# Access Compliance Report

### (Curb Ramps)

Intersection ID: 30545	Main Street: COLONY_RD	Cross Street: STONECROFT_PARK_DR	Location: NE
ADA ID: F00E98507038	Ramp Type: ParaDiag	Initial Pass/Fail: Fail	Overall Compliance: No
Severity Score: 12.5			
Codes/Mitigation Info/Possible Solution		Field Measurements/Component Compliance

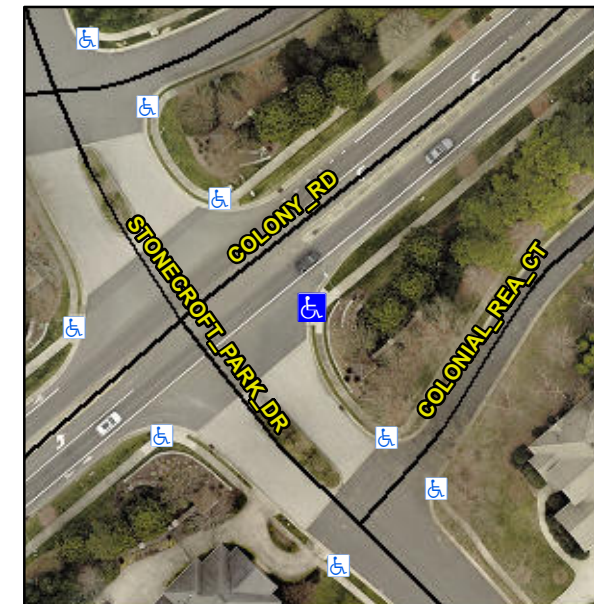
**LT RP < 5%**

**R304.3.2**

**Remove & Replace Curb Ramp With Two New Directional Ramps or Equivalent.**
